NO. 110C

2200/2600 #22C

2230 MXA/MXB HARDWARE CHANGES

This Newsletter supersedes the information contained in Service Newsletters 110, 110A and 110B.

5a. 2200E/F MOTHERBOARDS

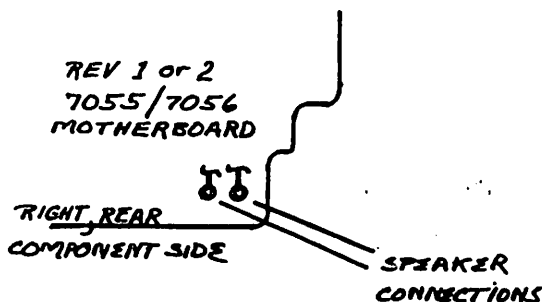
2200E Units with serial numbers under 1053 and 2200F units with serial numbers under 1030 have a potential problem with chassis ground. The motherboard frame does not come in constant contact with the motherboard ground track. The only symptom reported thus far which appears to be caused by this grounding problem is that the EXECUTE Key intermittently will not function. The manufacturing solution adds a #18 Ga. green/yellow ground wire from the motherboard ground track (see Figure below) to a chassis ground stud.

5b. In reference to installations of Option 60 (Key "clicker", Audio Alarm and Auxiliary BNC) on the same serial number units mentioned in item (5a.) above, the motherboard frame was occasionally found to be attached to the motherboard incorrectly. The result was that two eyelets (see Figure below, Rev. 1 or Rev. 2 7055/7056 motherboard only; not Rev. 0) used for the OP-60 speaker connections were covered over by the wide flange of the motherboard frame. The solution is to remove the motherboard frame and four pem nuts, reinstall the frame onto the motherboard with the narrow flange of the frame mounted on the connector side of the motherboard. Using the same screws just removed, resecure the frame with 4-40 hex nuts.

6. 7054/7058/7059 EXTERNAL CRT CONNECTIONS FOR OPTION 60

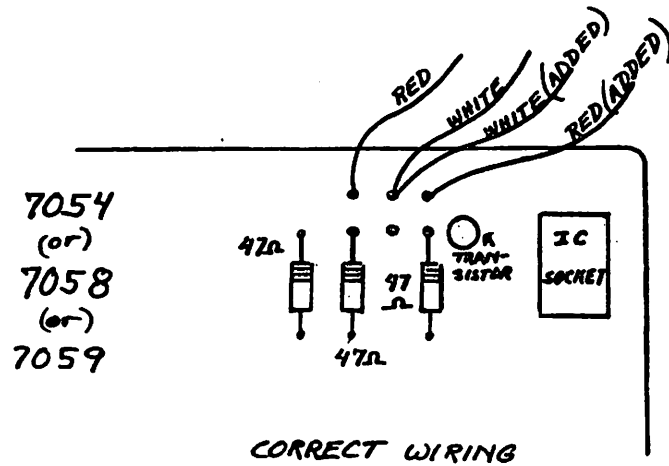
Several 2200E/Fs were shipped with Option 60 incorrectly installed on the 7054, 7058, or 7059 I/O controller. The external CRT wires should be installed as shown below. Incorrectly installed units have the wires placed in parallel.

ECN #8450 Rev 1

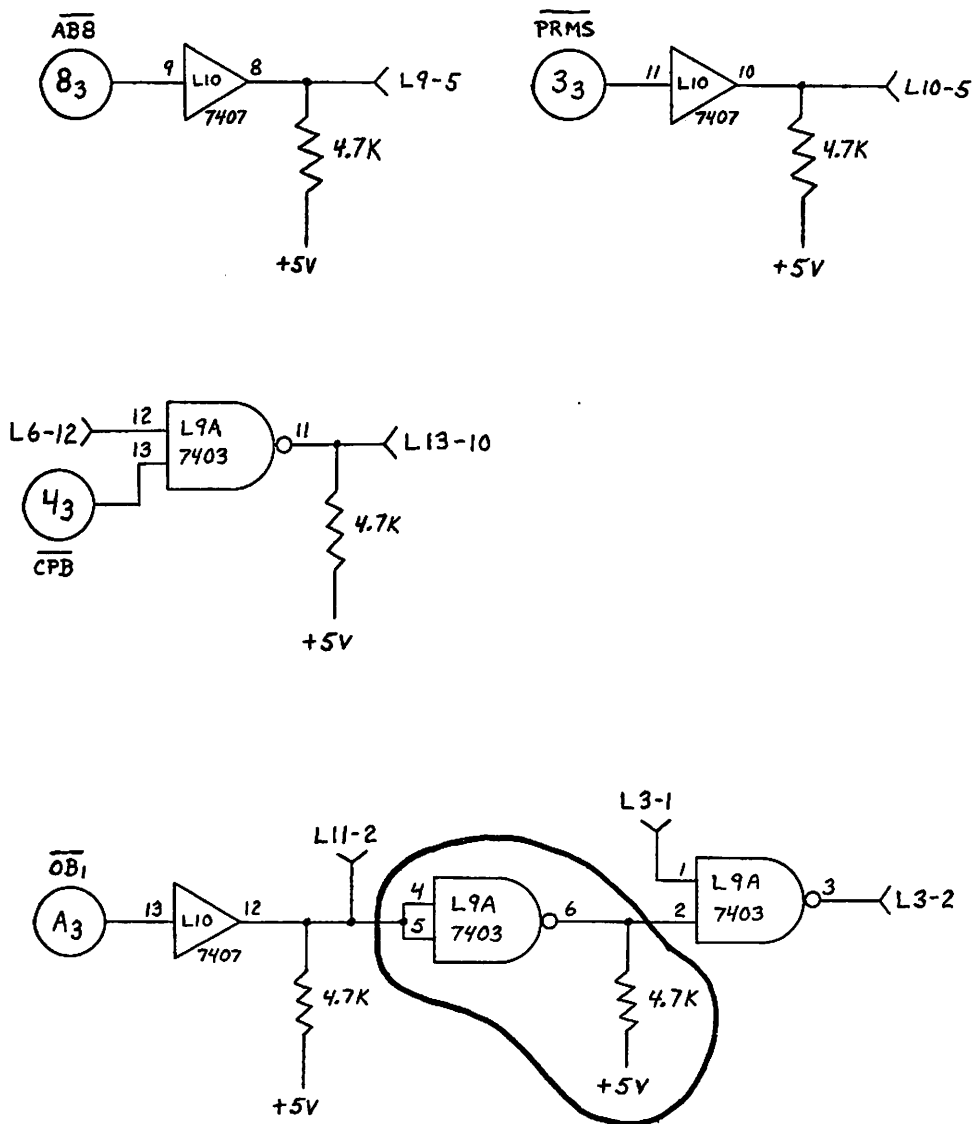
1. Change L11 & L15 from 74367 to 8T97 (376-0189).
2. Insert a 7403 (376-0028) into location L9A. Pin 1 should be located toward the bottom of the board. Connect pin 7 to +OV and pin 14 to +5V.
3. Cut the etch between connector 3₃ and L10 pin 5.
4. Cut the etch between connector A₃ and L11 pin 2.
5. Cut the etch between connector 4₃ and L13 pin 10.
6. Cut the etch coming from connector 8₃ at a point before it connects to any IC pins.
7. Isolate L2-1 from its existing etch by lifting pin 1 so that the etch remains intact.
8. NOTE: The following step is deleted by ECN #9256 and is included for reference only: Jumper L10-10 to L2-1.

Add five 4.7K ohm resistors (330-3047).

Add the following circuitry:

The encircled circuitry (L9A-4, 5 and the 4.7K pull up) is changed by ECN #9998 and is included in the figure for reference only!

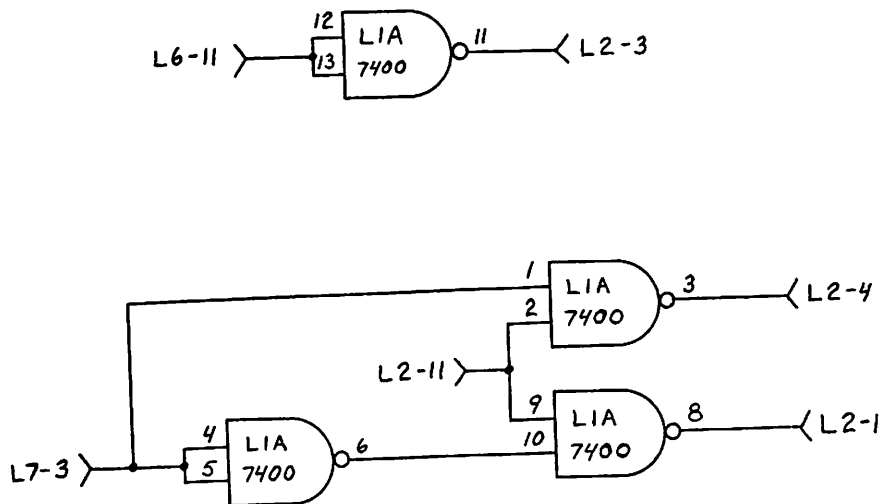
1. Insert a 7400 (376-0002) into location L1A. CAUTION: Some boards may have this 7400 located above L6. Pin 1 should be located toward the bottom of the board. Connect pin 7 to +0V and pin 14 to +5V.
2. Isolate pin 2 of L2 from the existing etch. Ensure that the etch is left intact to connect to all other components on that line. Do this by lifting pin 2.
3. Remove the wire connecting L10-10 to L2-1, and ensure that the 4.7K ohm pull-up resistor that is attached to this line connects to L10-10..
4. Cut the etch between L2 pin 3 and L2 pin 11.
5. Connect L2 pin 2 to +0V.

Add the following circuitry:

ECN #9650 Rev 3

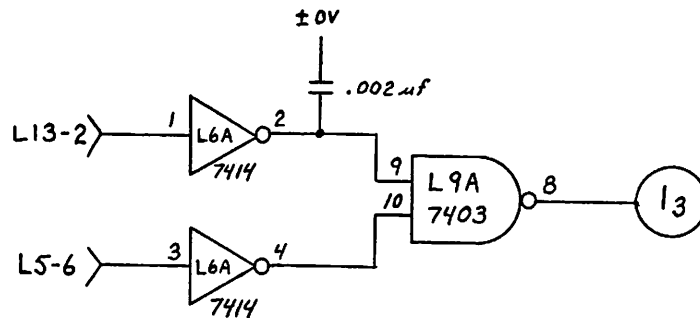
1. Insert a 7414 (376-0139) into the location above L6 (referred to as L6A). CAUTION: Some boards may have this 7414 in location L1A. Pin 1 should be located toward the bottom of the board. Connect pin 7 to +0V and pin 14 to +5V.
2. Cut the etch between connector L₃ and L13 pin 3.

Add one 0.002 uf cap (300-1913).

Add the following circuitry:

ECN #9998 Rev 4

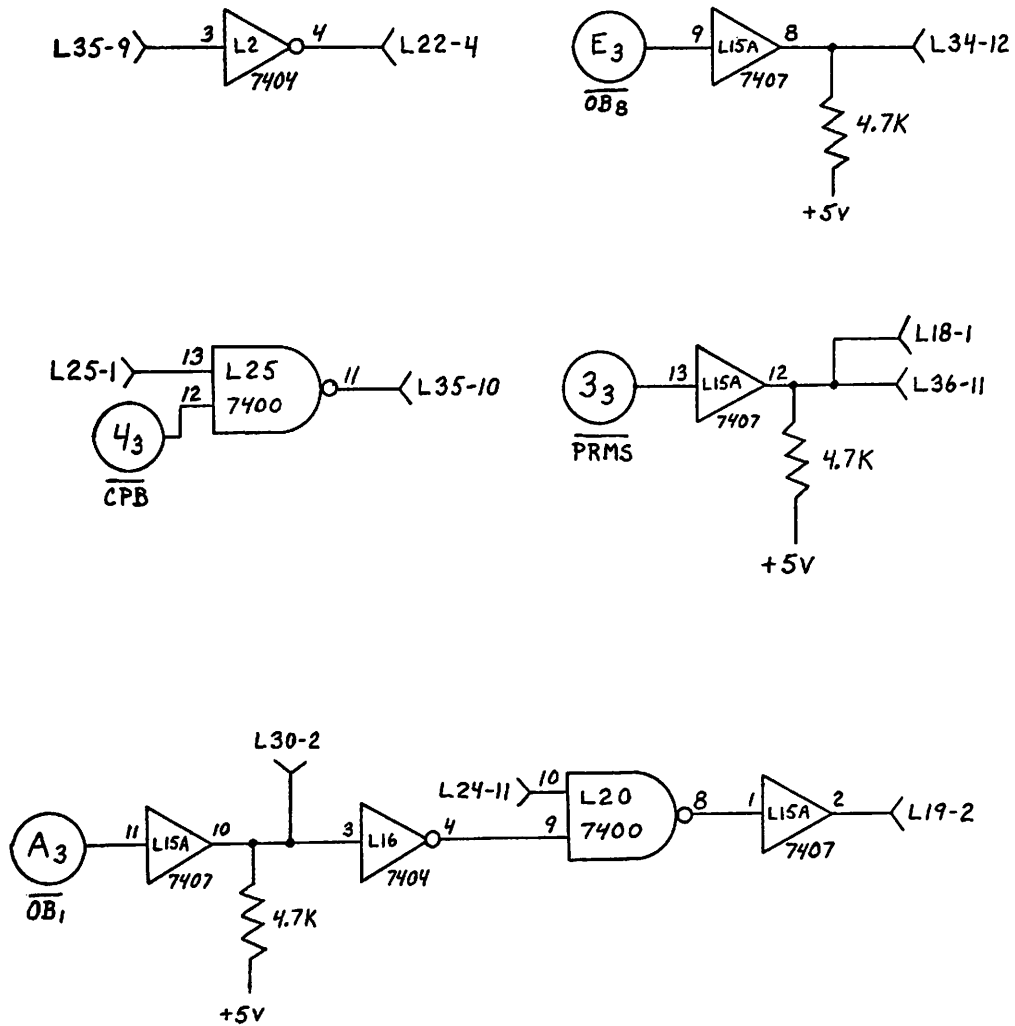
1. Cut the etch connected to L14 pin 7 at pin 7.
2. Remove the 4.7K pull up resistor that connects to L9A pin 6.
3. On R4 boards, cut the etch between L9A pins 4 and 5. On boards with artwork R3 and below, remove the jumper wire that connects L9A pins 4 and 5.

4. On R4 boards, cut the etch connected to L9A pin 4 at pin 4. On boards with artwork R3 and below, disconnect L10 pin 12 from L9A pin 4 or 5 (pins 4 and 5 were tied together). Ensure that L10 pin 12 is still connected to L11 pin 2 and that the 4.7K pull up resistor that was tied to L10 pin 12 remains so.

5. On R4 boards, cut the etch between L9A pins 2 and 6. On boards with artwork R3 and below, remove the jumper wire connecting L9A pins 2 and 6.

Add the following circuitry:

ECN #8666 Rev 2

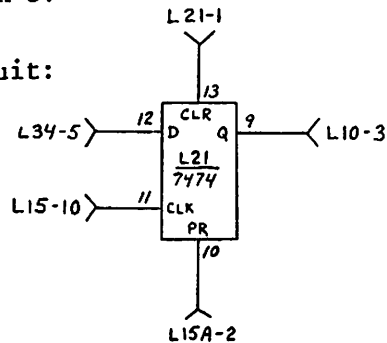
1. R15 should be 10K ohm (330-4011-4B). If it is not, change it. (schematic coordinates J3).
2. C13 should be 0.02 uf (300-1904). If it is not, change it. (schematic coordinates I4).

ECN #9515 Rev 4

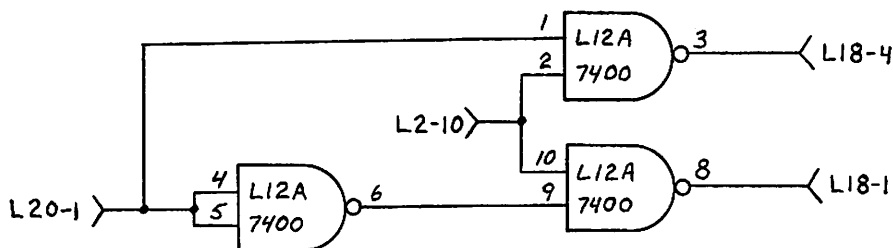
1. Isolate L18 pins 1 and 3 from existing etches. Ensure that the etches are left intact to connect to all other components on those lines. Do this by lifting pins 1 and 3.
2. Insert a 7400 (376-0002) into location L12A. Pin 1 should be located toward the bottom of the board. Connect pin 7 to +OV and pin 14 to +5V.
3. Change C17 to 0.1 uf (300-1901) (schematic coordinates F9).

- Change R24 to 47K (330-4047-4B) (schematic coordinates F9).

Add the following circuitry:

CAUTION: This ECN had one other change which created a 7287-2. If this change has been implemented and/or the board is marked with a "-2", the modification has to be removed.

The change was to isolate L12 pins 2 and 13 from the existing etches, and then jumper L12 pins 1, 2 and 13 together. The pins should not be jumpered and pins 2 and 13 must be reconnected to the etches that were connected to them.

ECN #9651 Rev 5

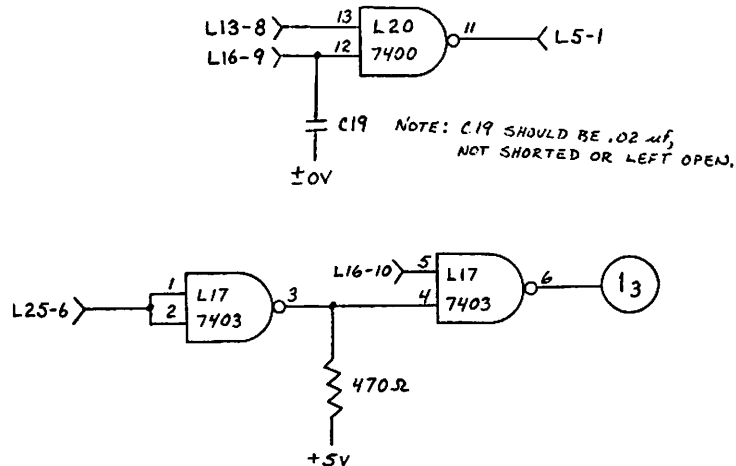
- Insert a 7403 (376-0028) into location L17 (may be referred to as L16A or L17A on some schematics. New schematics will refer to it as L17.) Pin 1 should be located toward the bottom of the board. **CAUTION:** On R1 boards, this 7403 may have to be inserted into location L15A.

2. Change C16 to 470 pf (300-5005) (schematic coordinates F9).
3. Cut the etch between connector 1₃ and L35 pin 3 at the connector.
4. Cut the etch between L16 pin 8 and L5 pin 1.
5. Add a 0.001 uf cap (300-1906) between L14 pin 4 and +OV.
6. NOTE: The following wire is removed by ECN #9997. It is included here for reference only. This wire should not be added!

Add a jumper wire from L12 pin 1 to L14 pin 3.

7. C19 should be loaded with a 0.02 uf cap (300-1904) (schematic coordinates I9). Location C19 may be open or shorted on previous boards.

Add one 470 ohm resistor (330-2047-4B).

Add the following circuitry:

ECN #9997 Rev 6

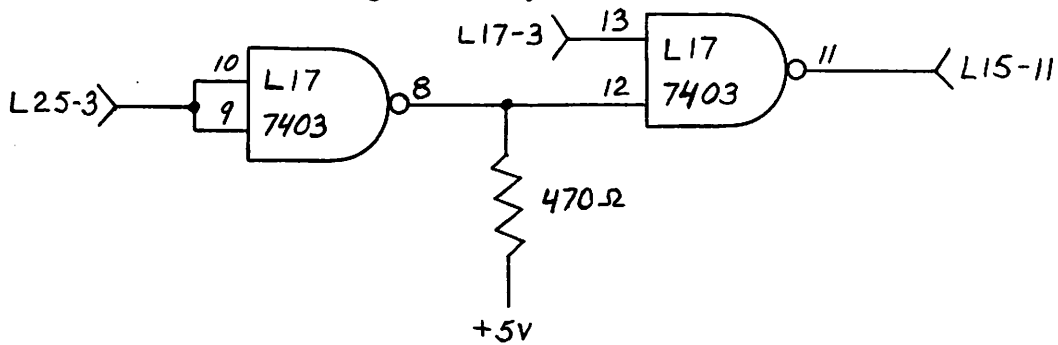
1. Cut the etch connected to L34 pin 7 at pin 7. Add one 470 ohm resistor (330-2047-4B).
2. Remove the wire connecting L12-1 to L14-3.

Add the following circuitry:

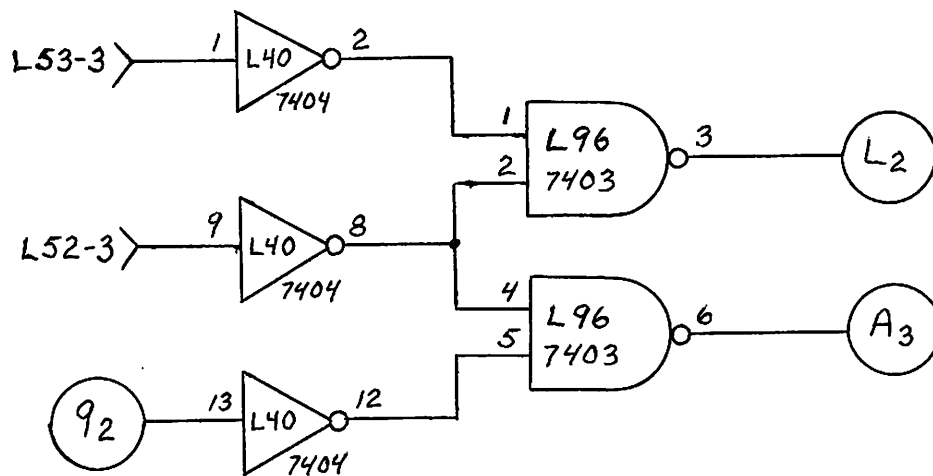
1. Insert a 7403 (376-0028) in location L96. Pin 1 should be located toward the bottom of the board. Connect pin 7 to +0V and pin 14 to +5V.
2. Cut the etch between connector L₂ and L95 pin 9.
3. Cut the etch between connector A₃ and L83 pin 13.

Add the following circuitry:

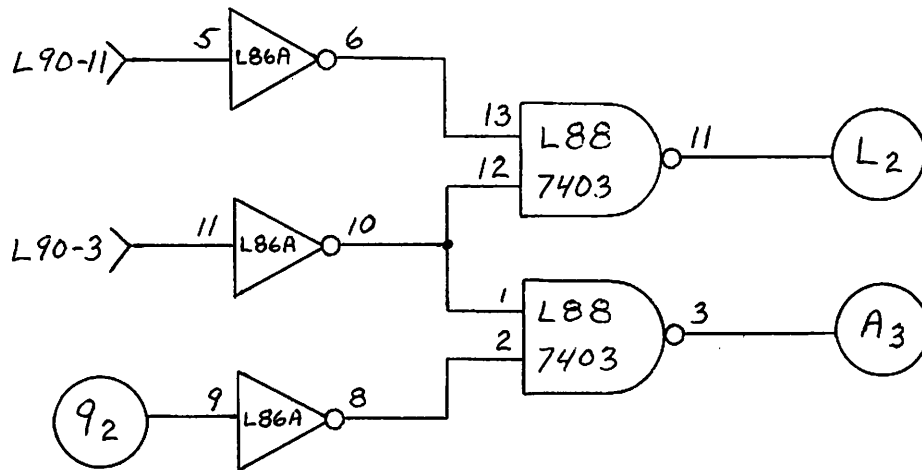
To allow the 7059-2 to operate in a WCS-15 configuration, remove the end of the wire that is connected to L100 pin 6 and connect it to L100 pin 4. On future boards a jumper location will be provided.

1. See above for 6786

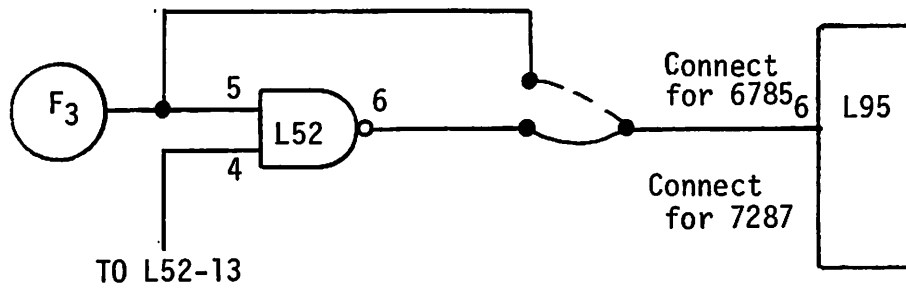
- MUX
B
1. For 6786
 - a) Insert a 7403 IC between L9 and L10 (L9A).
 - b) Connect +OV and +5 to pins 7 and 14 of the IC.
 - c) Cut etch at L13 pin 10.
 - d) Add a wire from L9A pin 11 to L13 pin 10.
 - e) Add a wire from L9A pin 13 to connector 3 pin 43.
 - f) Add a wire from L9A pin 12 to L6 pin 12.
 - g) Add a 4.7K ohm resistor between L9A pin 11 and + 5V.
 - h) Increment E-Rev from 2 to 3.

2. See above for 7054 and 7054-1

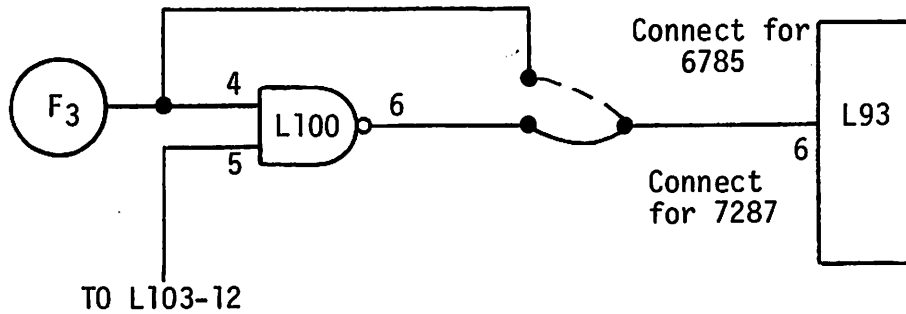
2. 210-7054 and 7054-1
 - a) Cut etch near L95 pin 6.
 - b) Add a wire from L52 pin 6 to L95 pin 6.
 - c) Add a wire from L52 pin 5 to connector 3 pin F3.
 - d) Add a wire from L52 pin 4 to L52 pin 13.
 - e) Increment the E-Rev from 8 to 9.

7. The following configuration is legal:

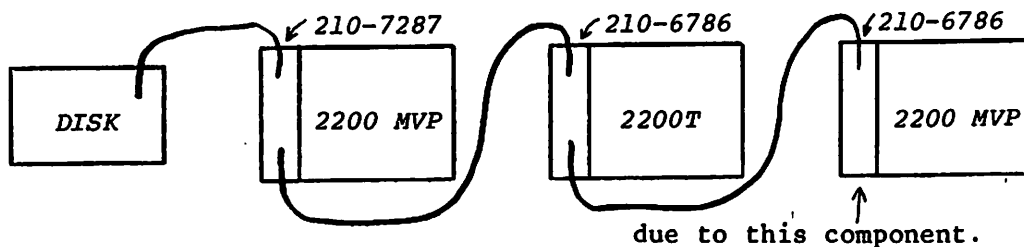
1. The 210-7287 will operate in any 2200 CPU (2200B/C/S/T/VP/-MVP)
 2. A 2230 MXB modified as described in Service Newsletters 110 and 110A MUST be used with the 210-7287.

8. The following configuration is NOT legal

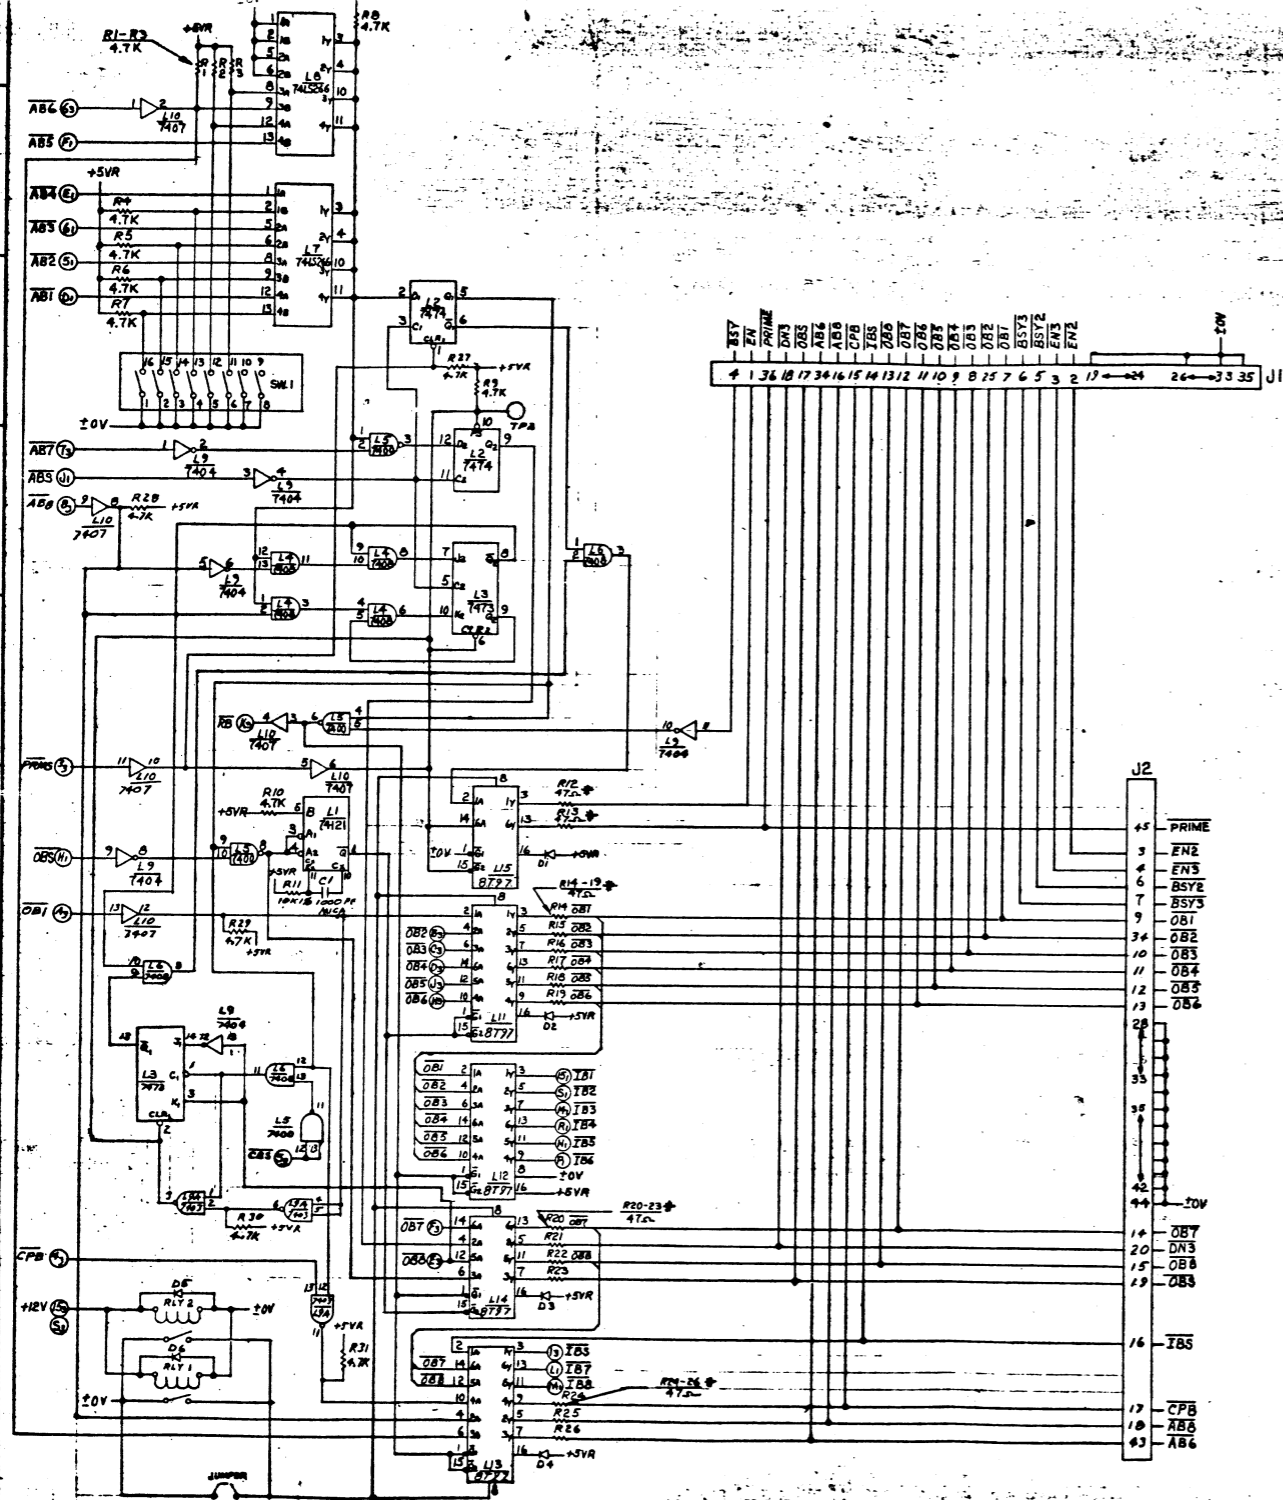
5. The 210-6786-1 can ONLY be used with the 210-7287.
 6. Present 210-6786 (not 210-6786-1) can be used with either the 210-7287 or the 210-6785 if the jumper change described in S.N. #110A is implemented. However, even when the 210-6786 is modified to accomodate the 210-7287, it CANNOT be installed in a 2200 MVP CPU chassis. It CAN be a slave controller in any other 2200 CPU that is used with a 2200 MVP System.
